March 11, 2021

**Re: Well #3 (L48752) Plan Review # 89-2019  
City of Cascade Locks (PWS ID # 4100172)  
Final Approval**

**SITE PLAN**

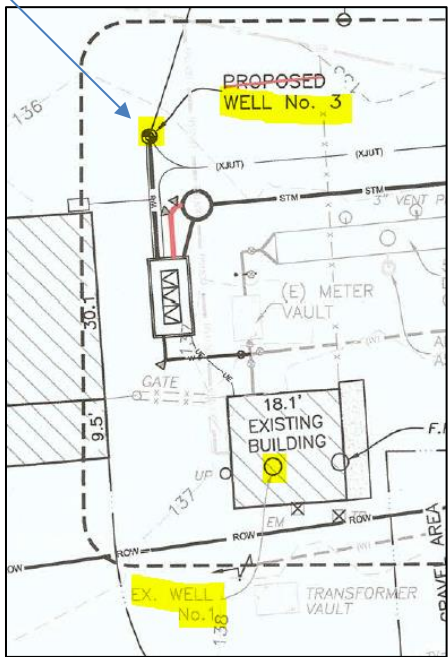
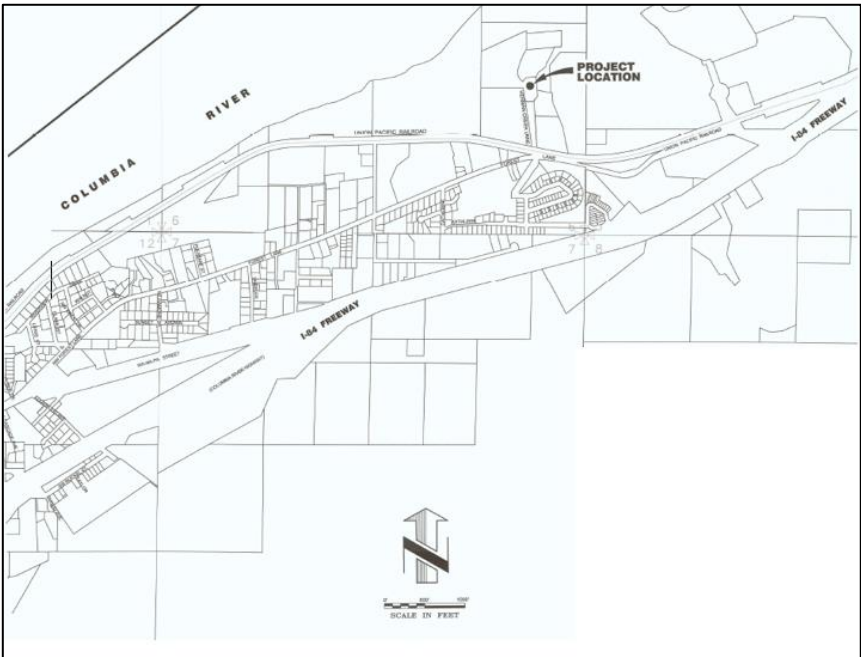
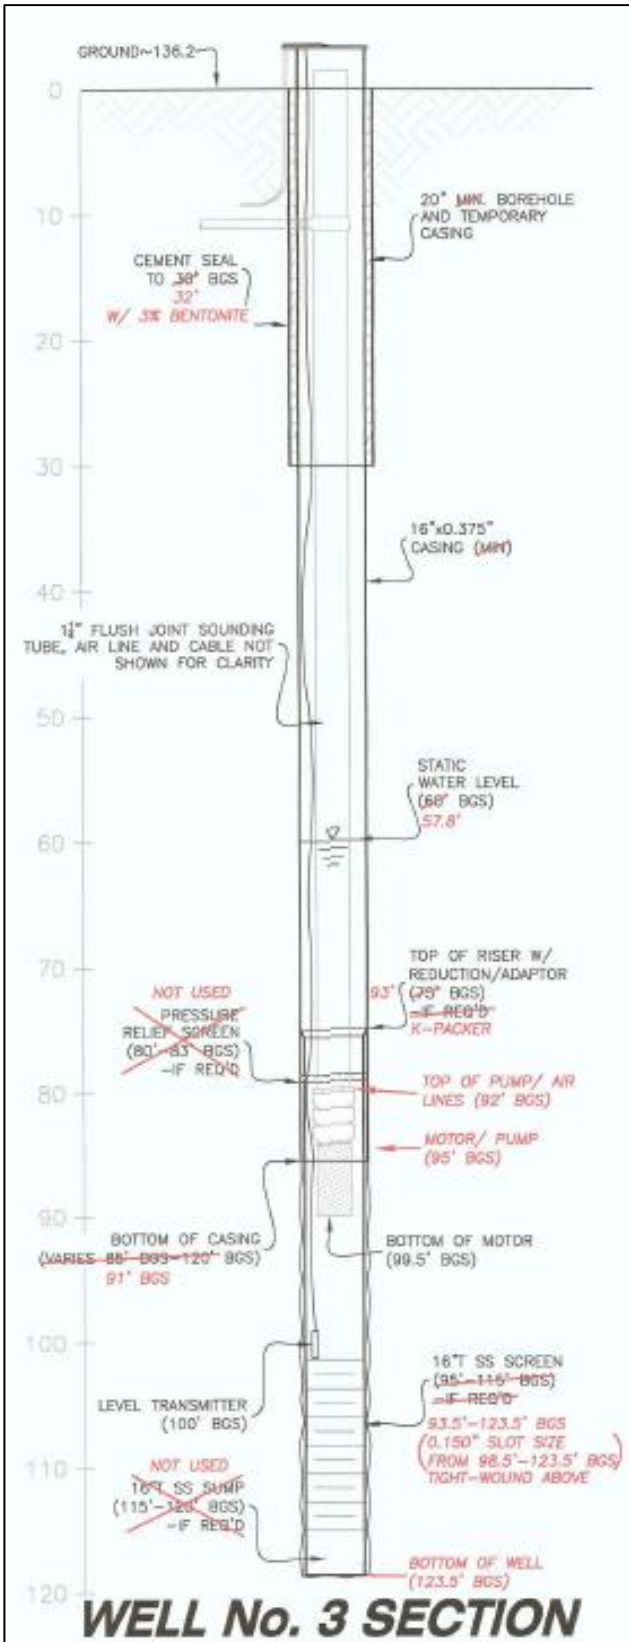
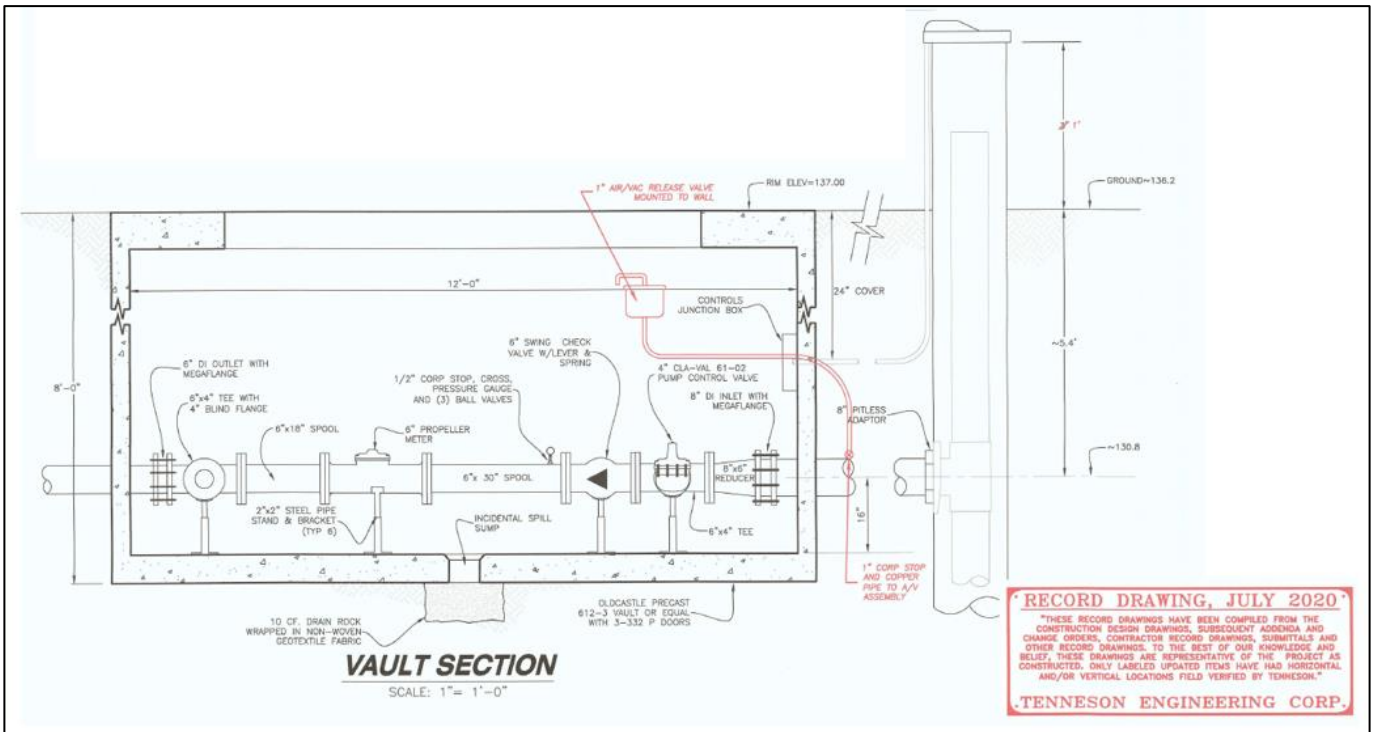
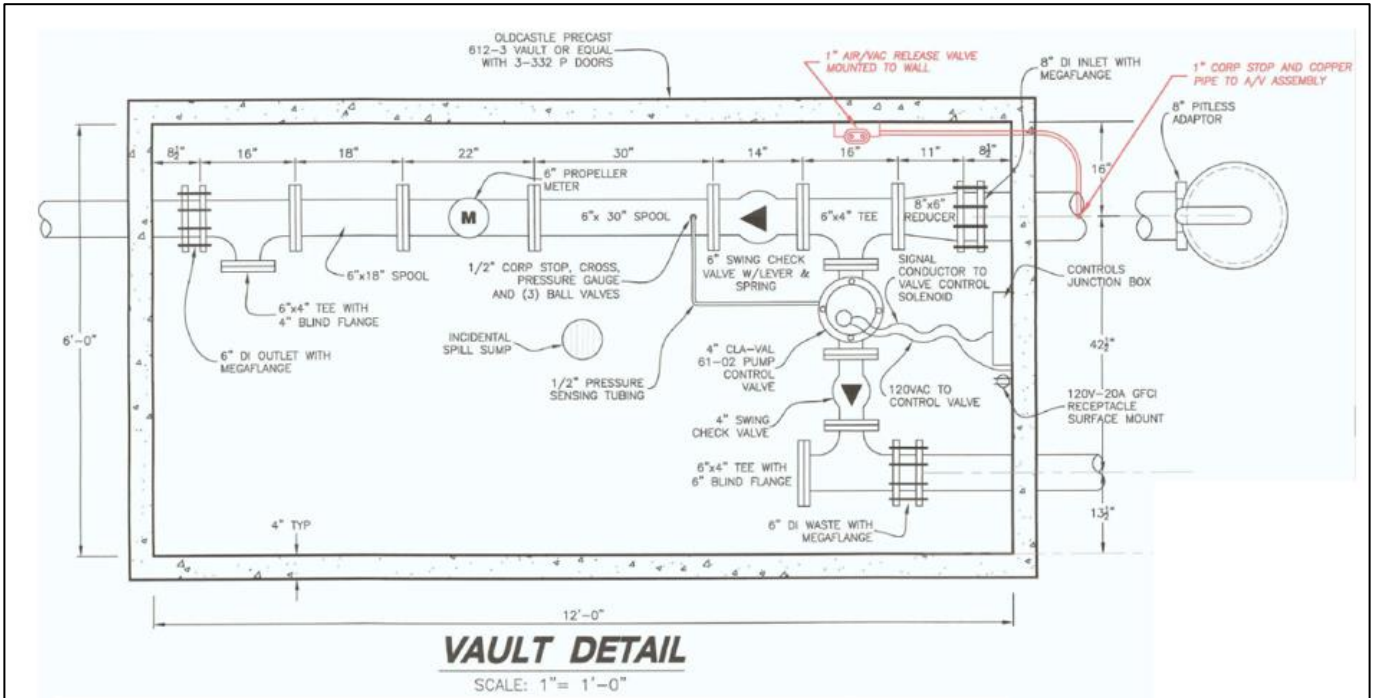
As noted in the well evaluation, due to the unconfined nature of the aquifer for Well #3, **Well #1 (MULT2057) will be considered a hazard setback deficiency** and may be indicated as such in water system surveys until Well #1 is either reconstructed or abandoned. Water quality problems that come up in the future with Wells #1 or #3 may also require that Well #1 be abandoned.

The well was fitted with a pitless adapter with a vault containing the flowmeter and control valves as shown in the record drawings below.
